Peer Review of Ross River Flood Study

Townsville City Council
A10416
001
00
5 April 2022

This peer review report documents the review findings for the modelling contract undertaken for the **Ross River and Surrounds** as presented within the *Ross River Flood Study Base-line Flooding Assessment* by AECOM (AECOM, 2021).

Figure 4.1 Missing Cross Drainage – Lavarack Barracks

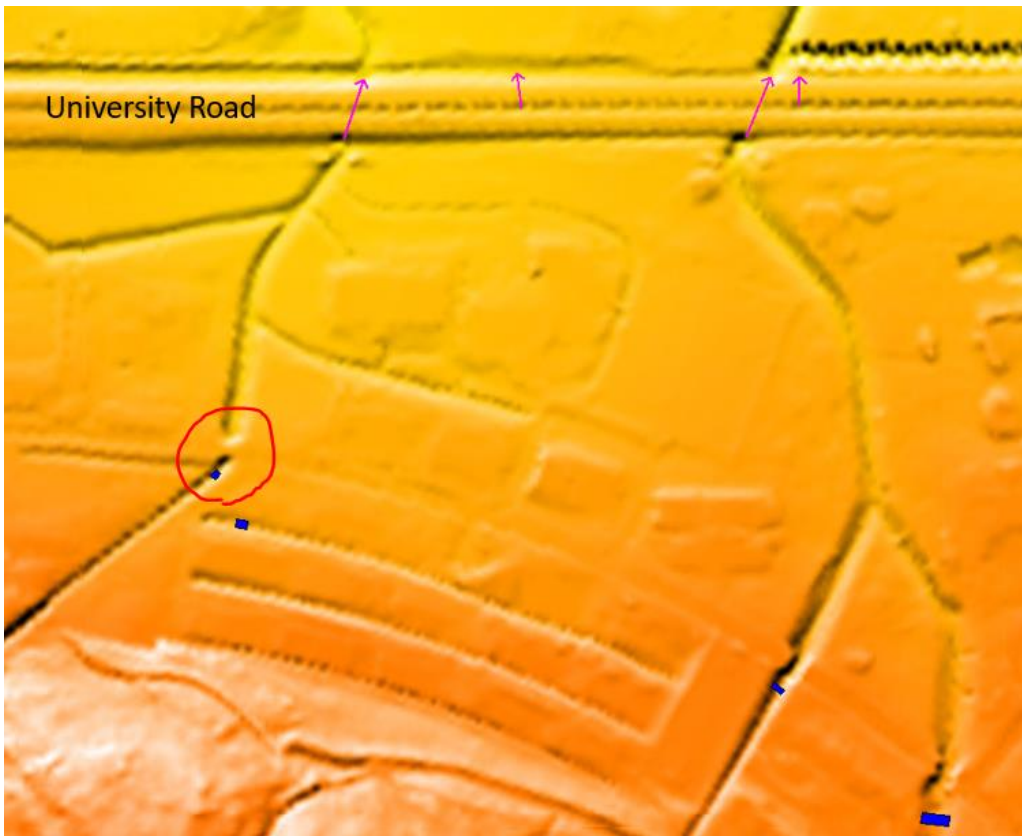
Some locations were identified where there is a crossing of a waterway (which is represented in the LiDAR) and where no provision has been made for cross drainage. These are typically minor and will not have any bearing on riverine flood results. An example is shown in Figure 4.1 within the Lavarack Barracks where an SA inflow (blue polygon) is applied upstream of a crossing of a drainage channel. Water will backup behind the cross drainage structure and will spill over or around it, potentially creating new flowpaths.

Our general recommendation is to incorporate a short statement that any third party use of the model at a more localised scale should review the culvert/pipe representations and update if required.

4.5	Some culverts not included on minor drainage channels eg within the barracks	Include short statement on the limitations of the assessment
4.6	A default map cutoff depth is applied which will differ to that requested by TCC (of 0.1m).	Cutoff depth applied appears reasonable but TCC to review against requirements.
